66309D-03

S E R V I C E N O T E

66309D

Reliability Improvement of Instrument

CORRECT J207 PLACEMENT – alignment to within $< 0.3\text{mm}$

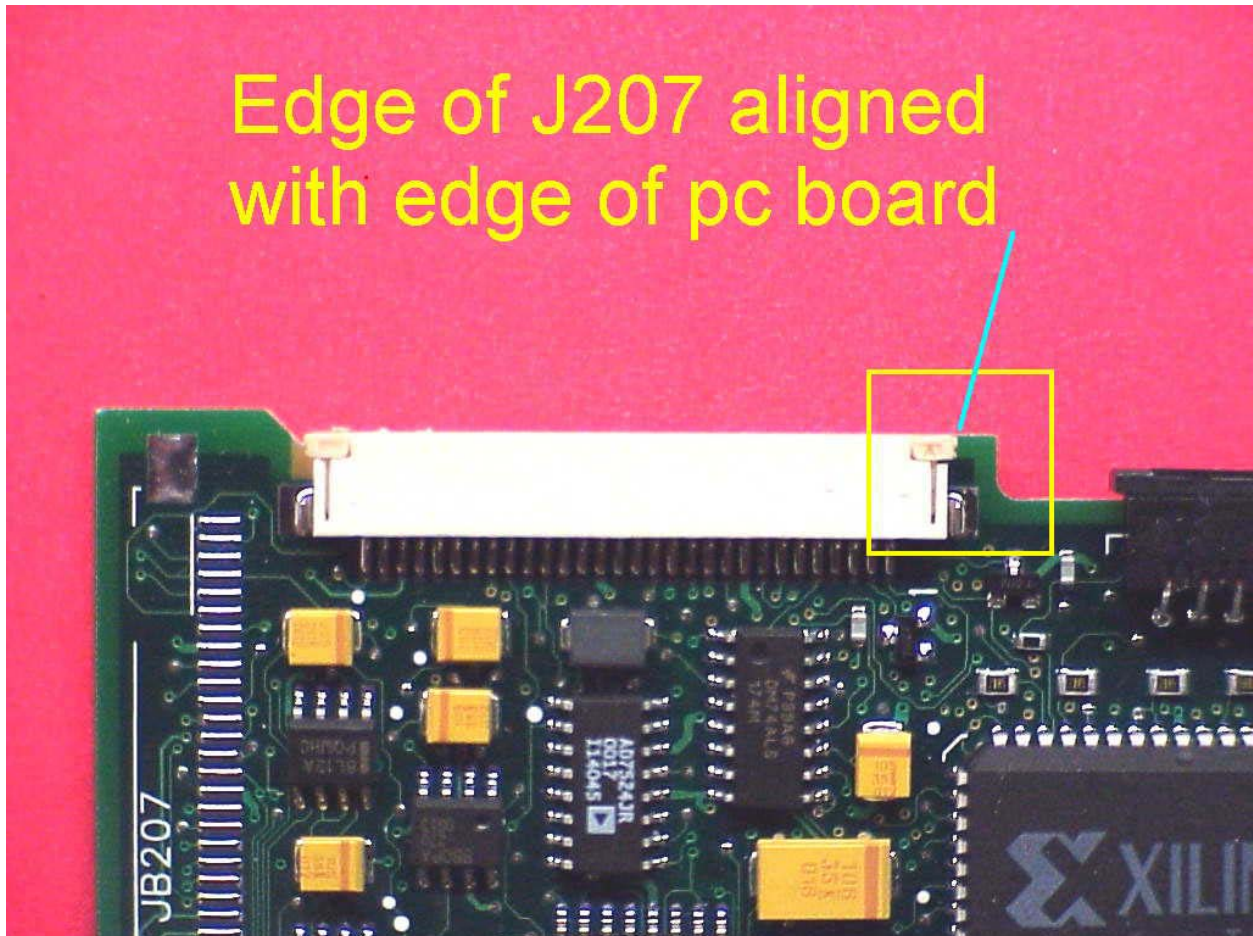
Latent product failure due to misplaced connector J207 on SMT assembly 5064-0018 (GPIB/RS232 interface). Misplacement of J207 could lead to inadvertent contact/shorting of exposed feed-throughs on SMT board. Ultimately, resulting in over-stress of components of damage to SMT board components. Resulting contact could degrade useful life of instrument.

Picture shows connector aligned to edge of SMT board to within $< 0.1\text{mm}$

- 1) Compare placement of J207 to attached photos. Instruments with a “misplaced” J207 should be returned to Agilent for warranty repair.
- 2) Instruments returned to the Service Center for routine calibration should be inspected for this potential defect. Defects should be addressed using Agilent’s unit exchange process with costs being charged to warranty.
- 3) The factory has modified production documentation to include visual inspection and specific electrical testing for this potential short.
- 4) Factory is maintaining feedback to SMT board supplier regarding quality of assembly.

INCORRECT J207 PLACEMENT – misaligned by $> 0.3\text{mm}$

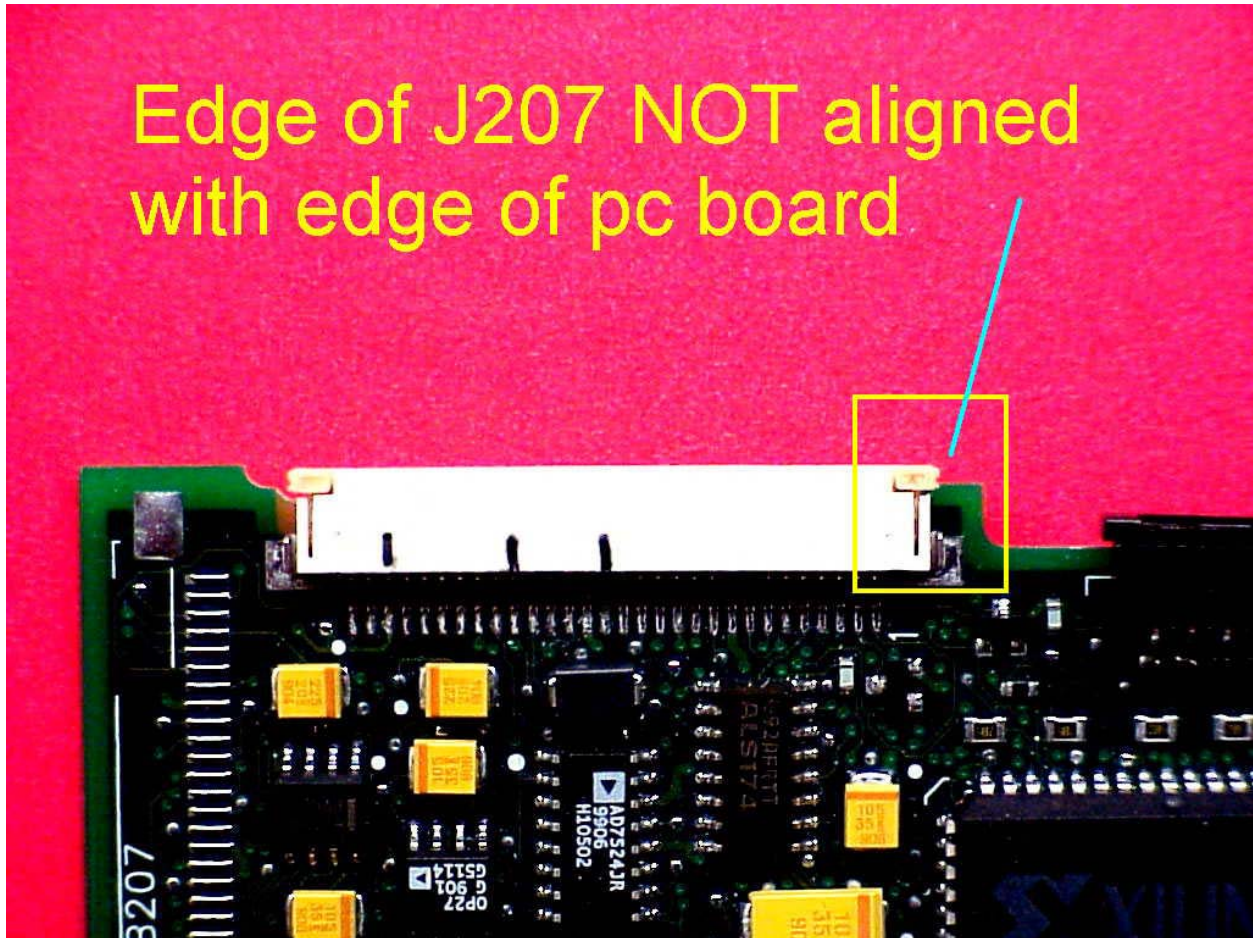
Picture shows connector extending past edge of SMT board by $>1.2\text{mm}$
